# Timing diagrams

rev.: 1.1

# Autoclass timing

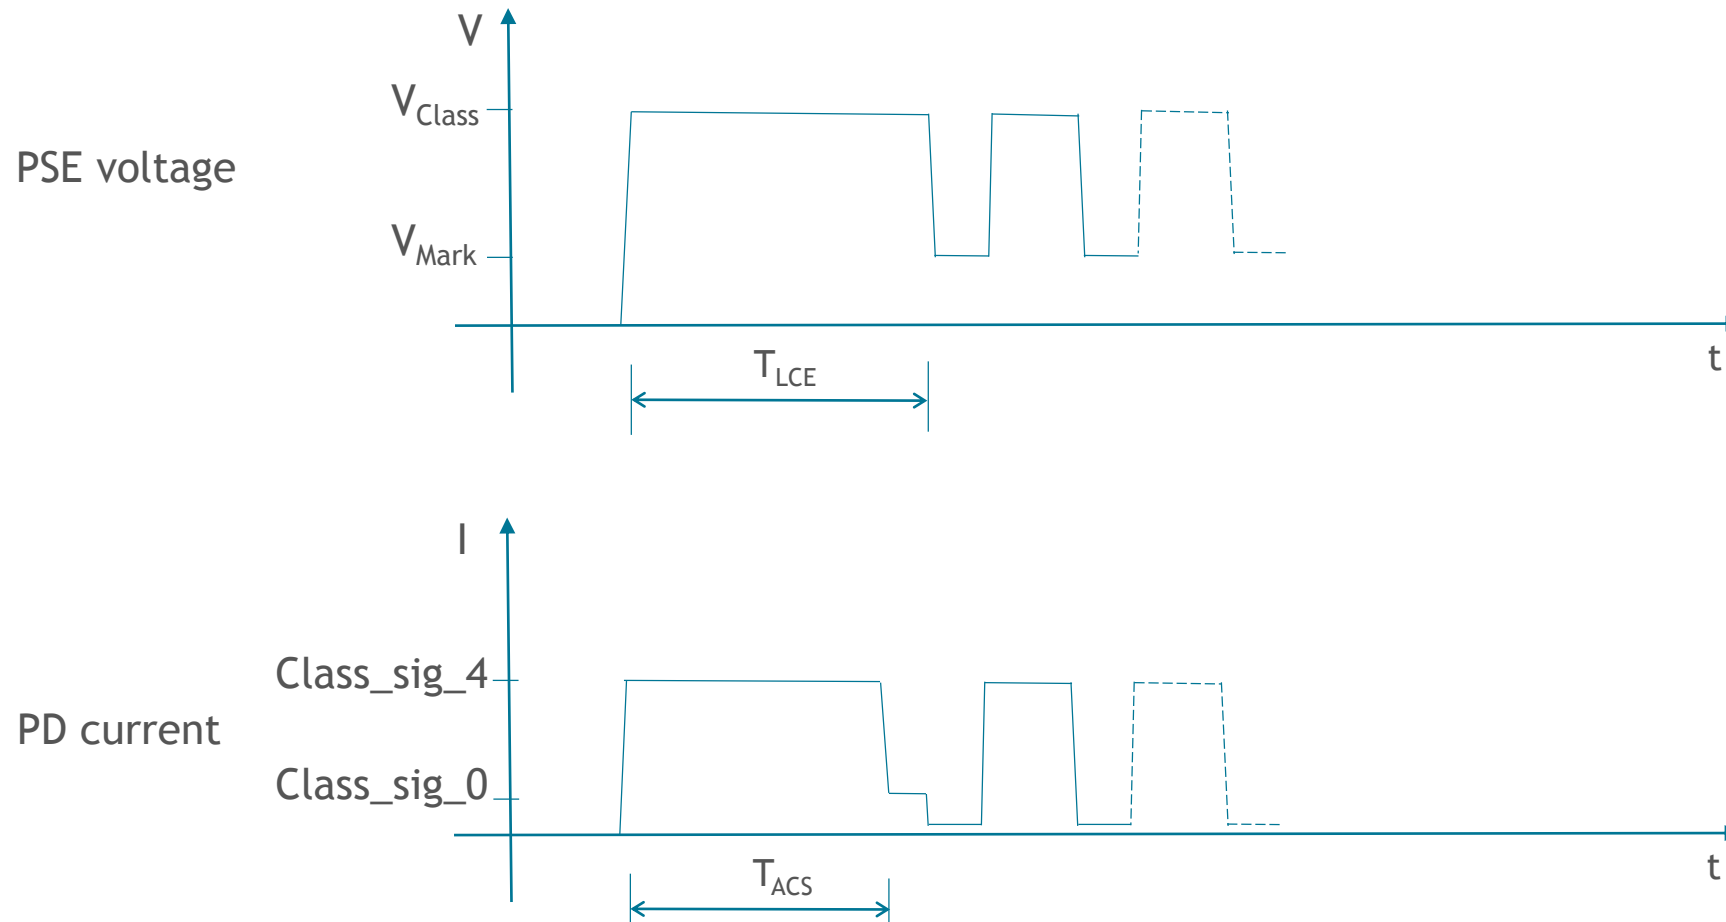
comment #63

- Into section 33.2.5.11 PSE Type 3 and Type 4 functions: `do_autoclassification`
  - Type 3 or Type 4 PSE and PD autoclass example

# Connection Check sequence diagrams

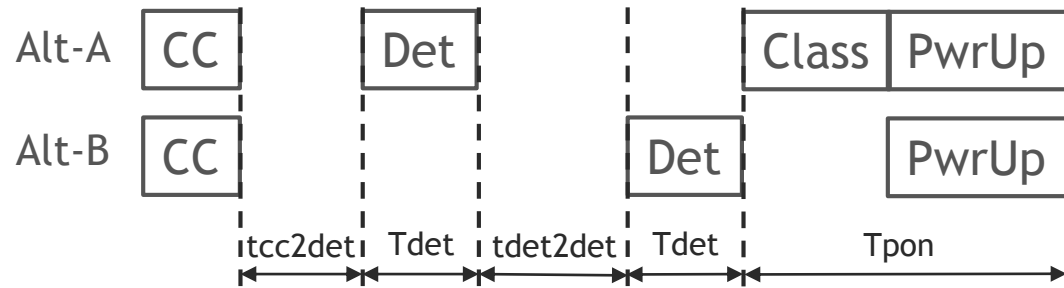
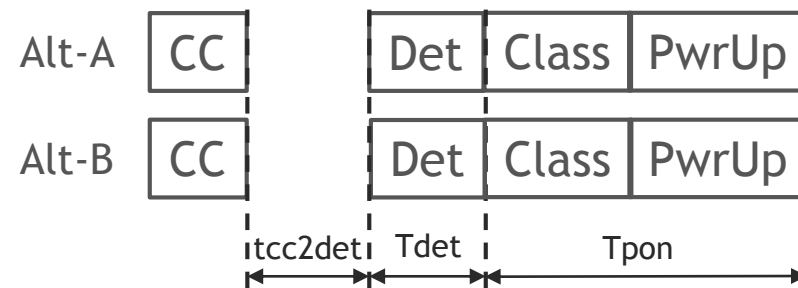
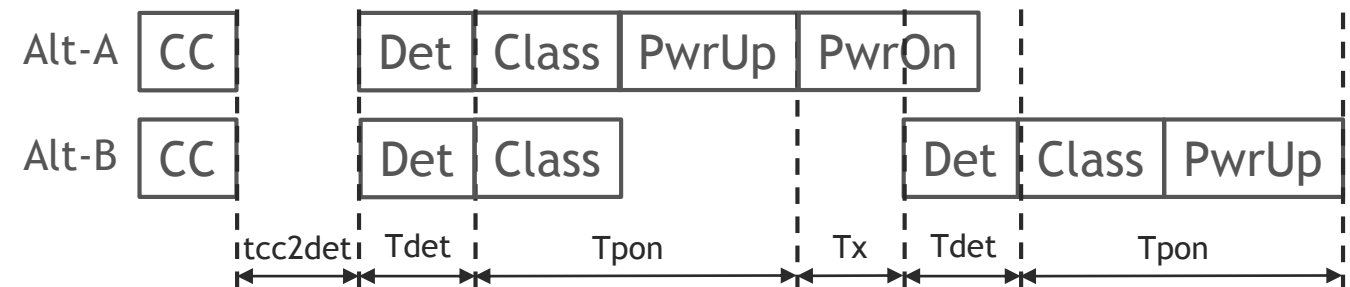
comment #64

- After CC\_DET\_SEQ constant description in section 33.2.5.8
- CC\_DET\_SEQ = 0

- The Alternatives are interchangeable
- Tx is application dependent

# Connection Check sequence diagrams

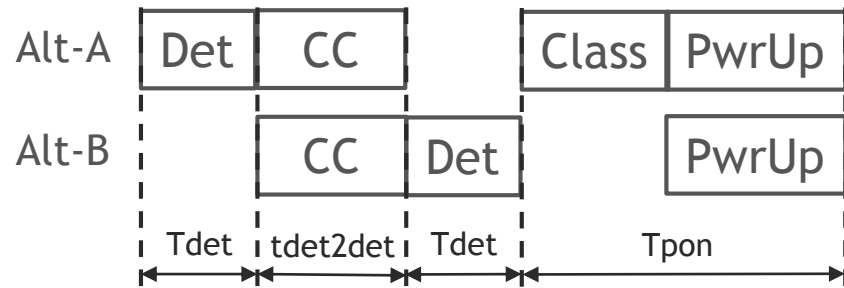
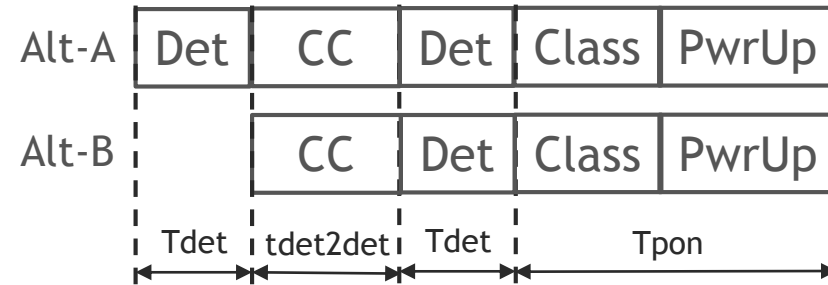
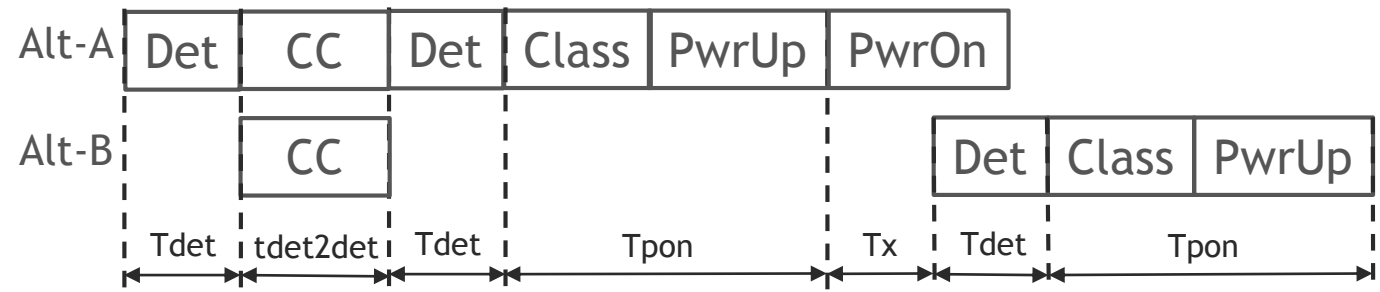
comment #64

- CC\_DET\_SEQ = 1

- The Alternatives are interchangeable
- Tx is application dependent

# Connection Check sequence diagrams

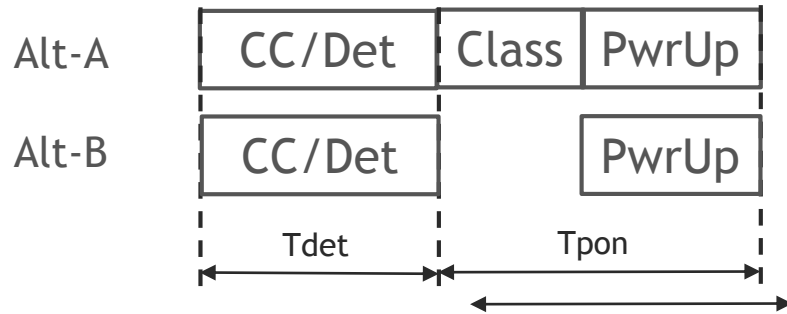
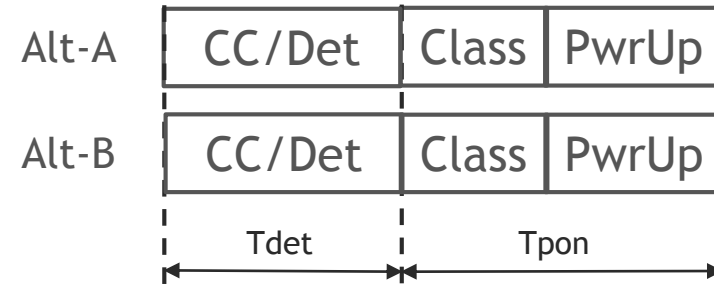
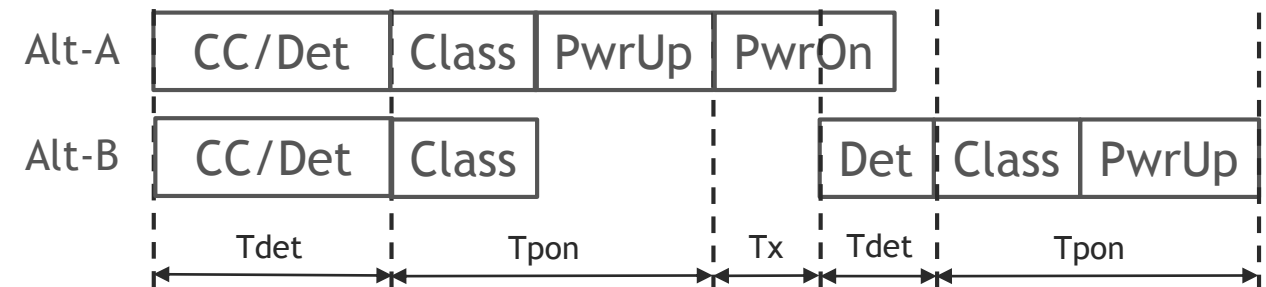
comment #64

- CC\_DET\_SEQ = 2

- The Alternatives are interchangeable
- Tx is application dependent

# Connection Check sequence diagrams

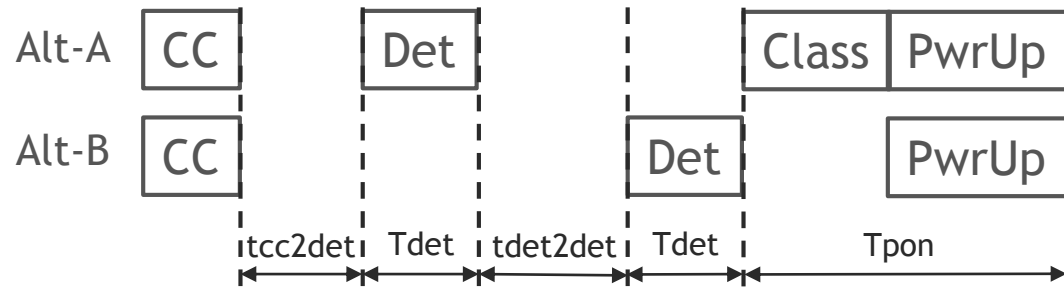
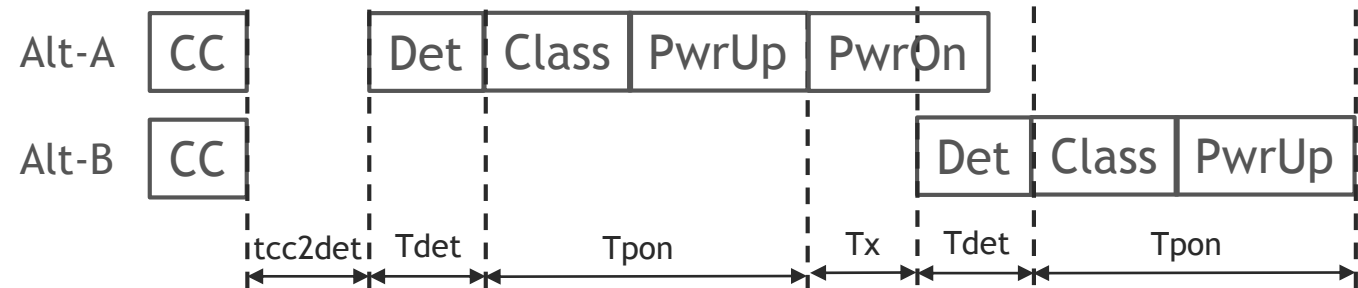
comment #64

- CC\_DET\_SEQ = 3

- The Alternatives are interchangeable
- $T_x$  is application dependent

# Single-Event classification

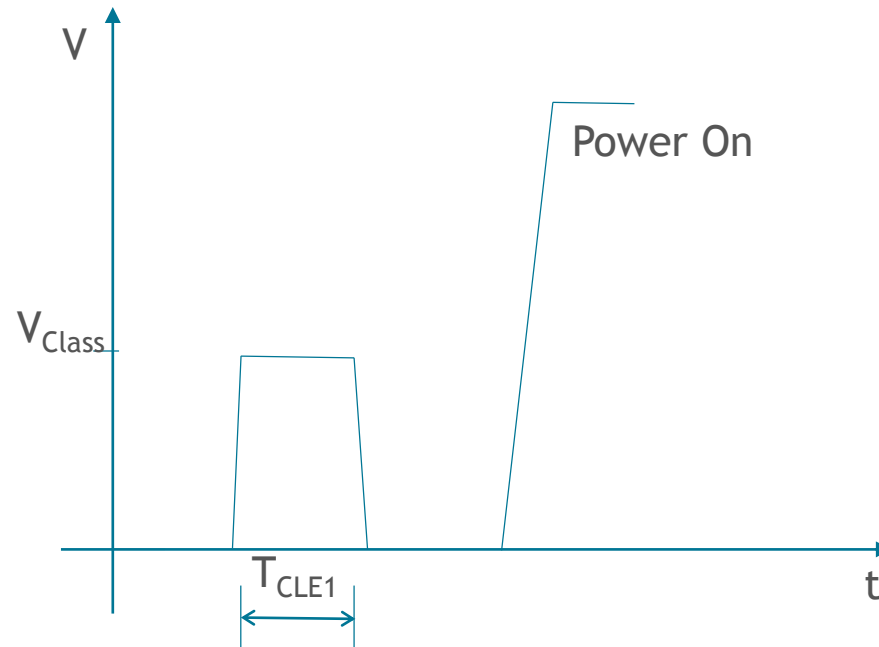
comment #59

- Into section 33.2.7.1 PSE 1-Event Physical Layer classification

# Multiple-Event Physical Layer classification

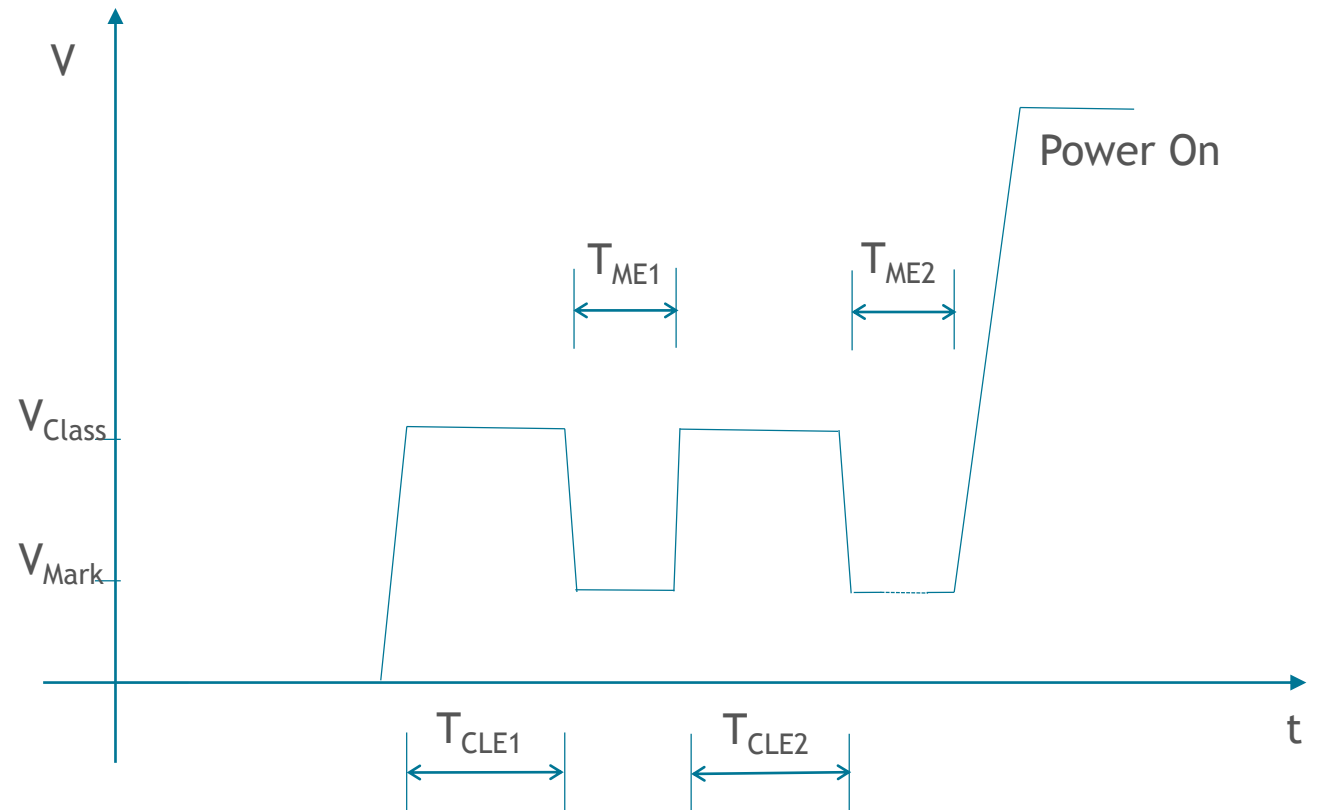
comment #60

- Into section 33.2.7.2 PSE Multiple Event Physical Layer classification
  - Diagram 1: Type 2 PSE - Class 4 PD

# Multiple-Event Physical Layer classification

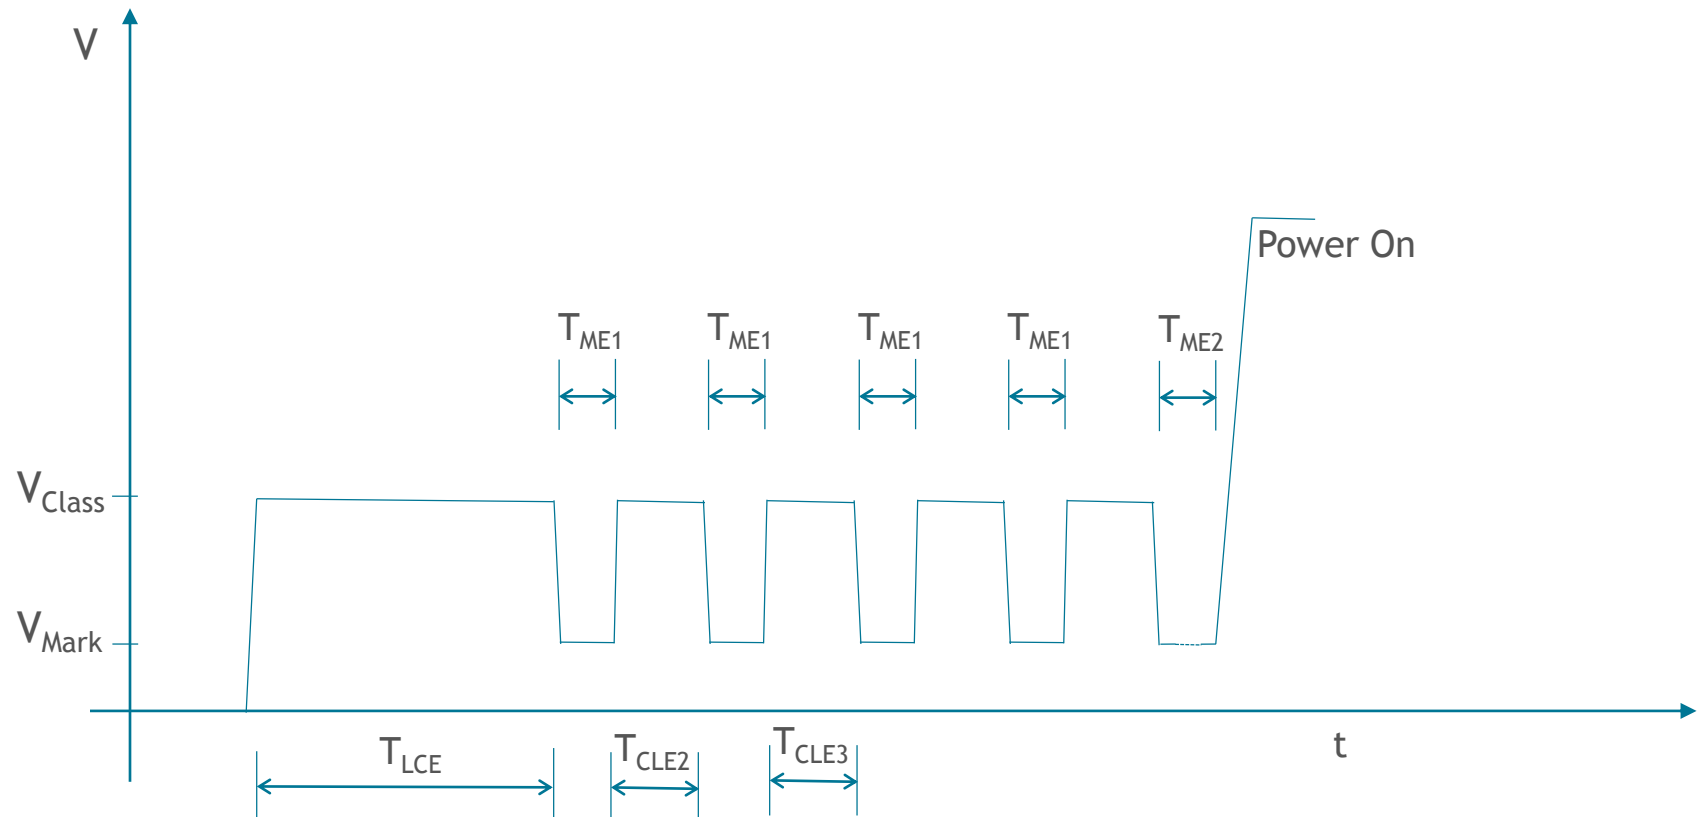
comment #60

- Into section 33.2.7.2 PSE Multiple Event Physical Layer classification
  - Diagram 2: Type 4 PSE - Class 8 PD - no autotclass
